SUBJECT: Minor Subdivision with Lot Consolidation and Bulk Variance Application No. S-1/23
Venkata Surya Kiran Akella & Purnima Kothapalli, 2181 & 2191 Brunswick Avenue
Tax Map Page 15, Block 1504, Lots 1, 2 and 3

DATE: June 14, 2023

Re: **Akella & Kothapalli Minor Subdivision**
Minor Subdivision Application
Block 1504 Lots 1, 2 & 3
2181 – 2191 Brunswick Avenue
R-4 Residential Zoning District

Date: June 29, 2023

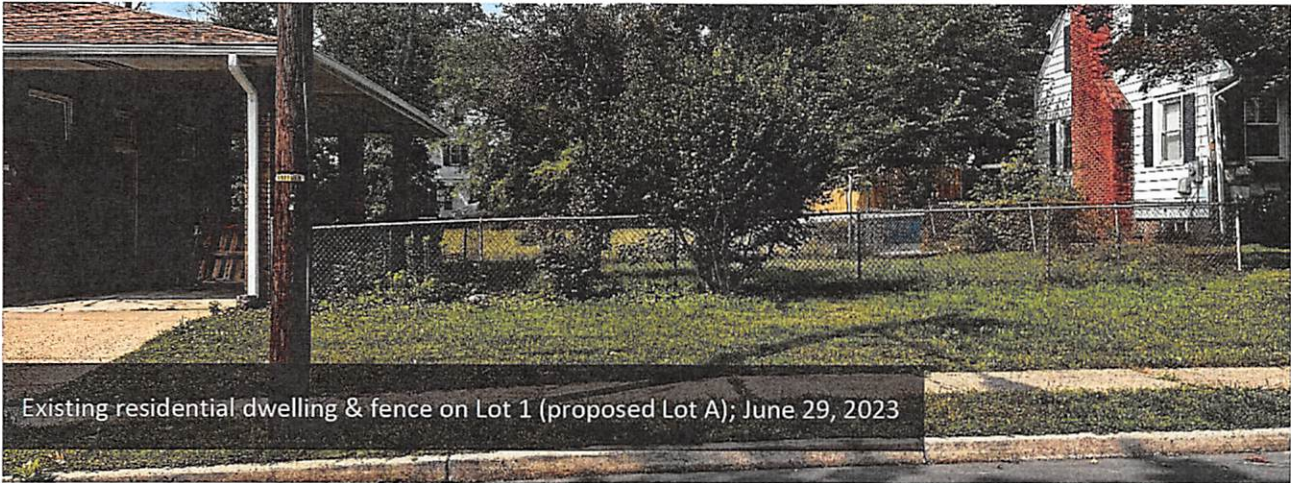
- 4.1** An existing chain link fence is located on the proposed Lot A, however it is not noted on the plan. Clarification should be provided regarding if the fence is proposed to be removed.

- 4.2** The steps on the existing dwelling appear to be in disrepair, they should be repaired.

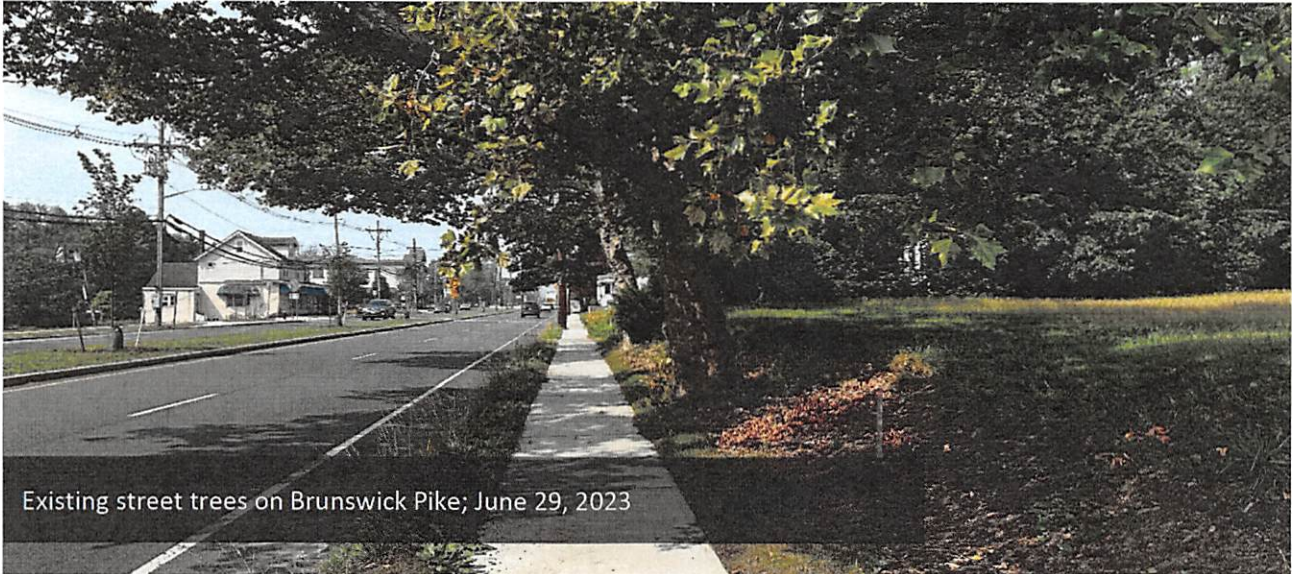
- 4.3 The total building height of the proposed building should be depicted on the Architecture Plans.
- 4.4 In accordance with §525.C.2, street trees are required every 30 feet. Lot A would require 5 trees along the Bunker Hill frontage and 2 trees along the Brunswick Pike frontage. There are no street trees along the Bunker Hill Avenue frontage, and it appears the existing street trees along Brunswick Pike are on the proposed Lot B. The required number of street trees should be provided, or the appropriate relief should be requested.

- 4.5 In accordance with §525.C.2, street trees are required every 30 feet. Proposed Lot B would require 3 trees along the Brunswick Pike frontage. It appears two mature street trees exist along the Brunswick Pike frontage, clarification should be provided regarding the preservation of these trees. The required number of street trees should be provided, or the appropriate relief should be requested.
